# **AEMA Comments on PJM's Initial DER Strawman**

May 19, 2021

PJM DIRS

PJM slides 30-47

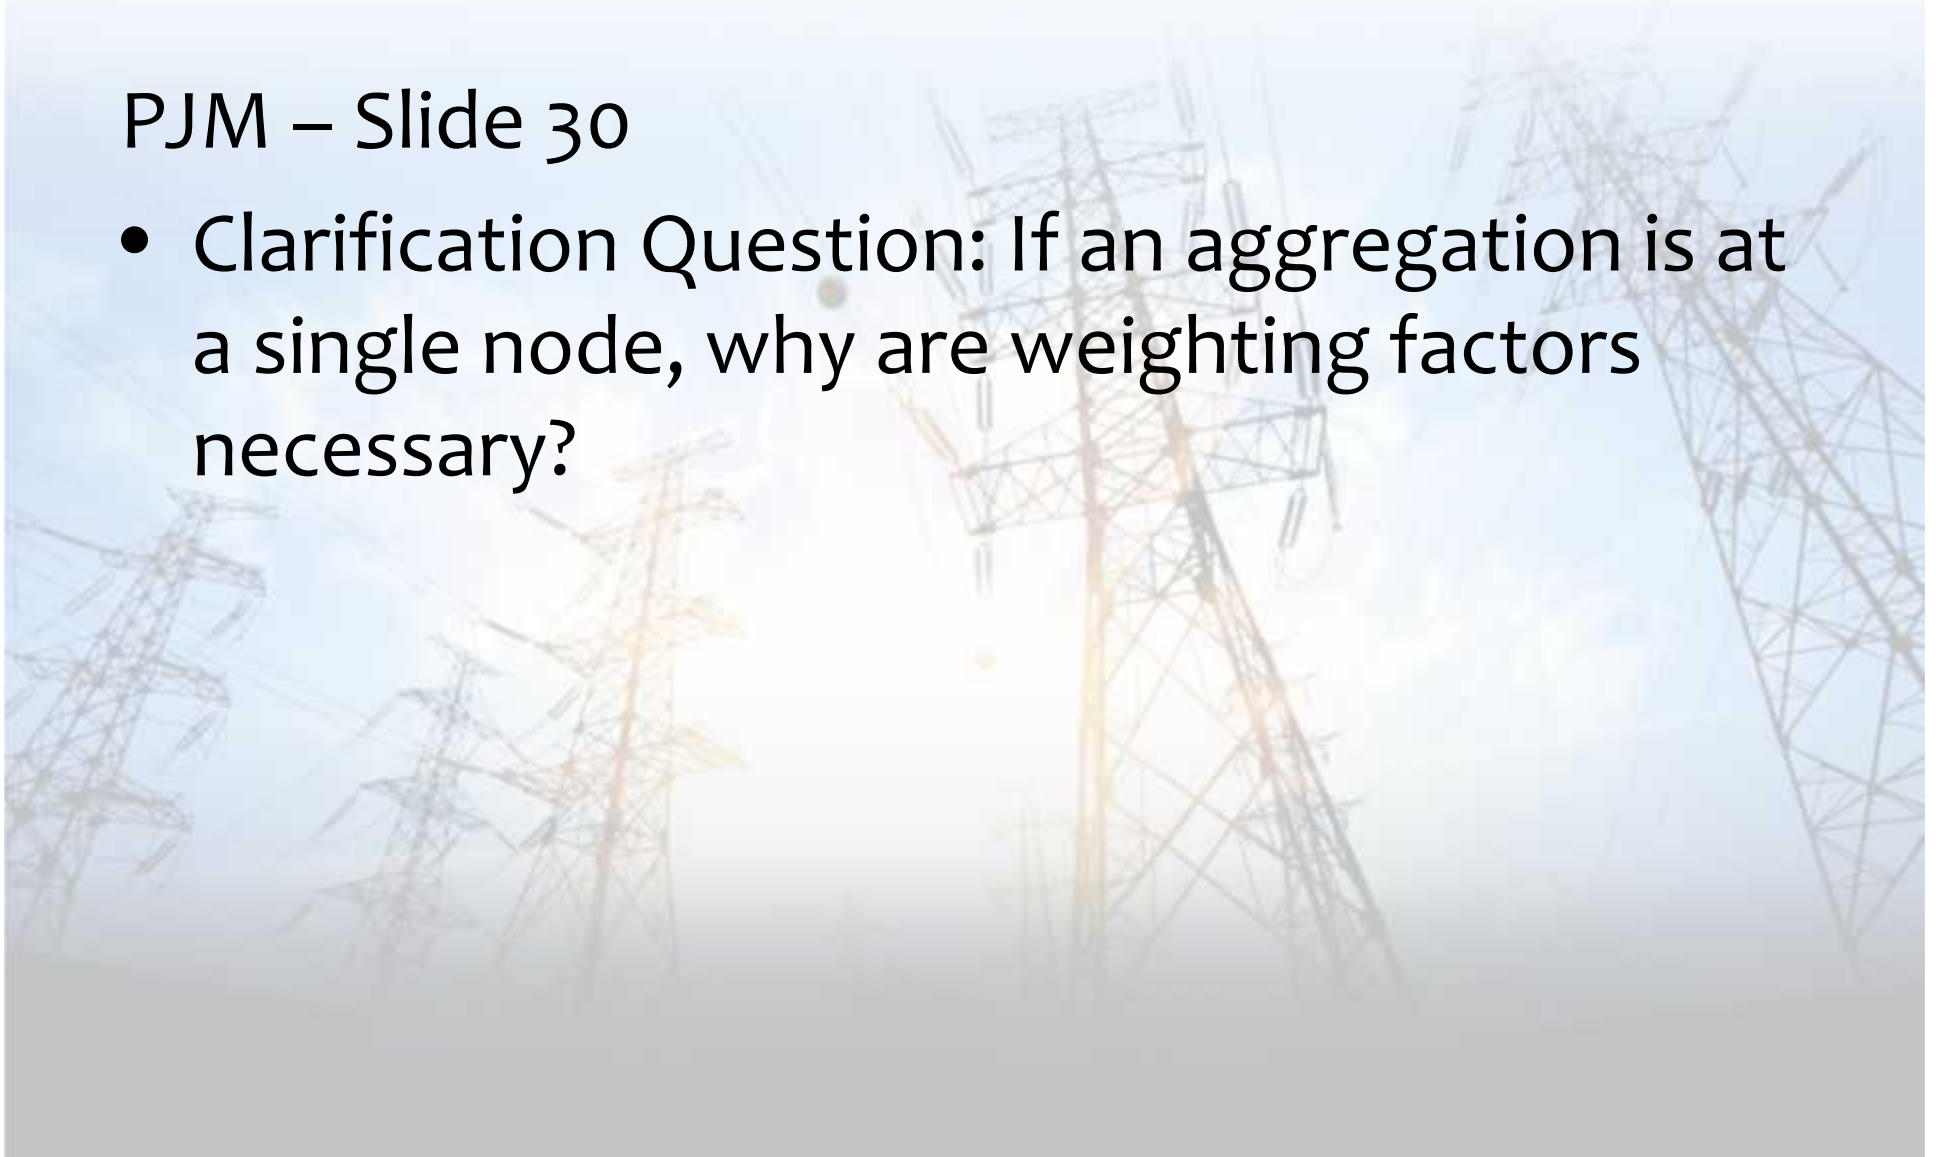
- Node mapping – AEMA is concerned that limiting aggregations to a single node will result in a) smaller DERs not meeting the 100 kW minimum threshold and b) large numbers of very small “aggregations”, thwarting the goals of aggregation itself.
  - FERC directs: “Establish locational requirements for DER aggregations that are as geographically broad as technically feasible.”
- Recommendations
  - Enable multi-node aggregations.
  - Investigate the feasibility of limiting aggregations only across nodes with frequent constraints, while allowing larger aggregations across nodes that are seldom constrained;
  - In more constrained areas, at least allow smaller DERs to aggregate across nodes to meet the 100 kW threshold as long as they don’t exceed 1 MW
  - Broad aggregation for capacity and ancillary services is necessary
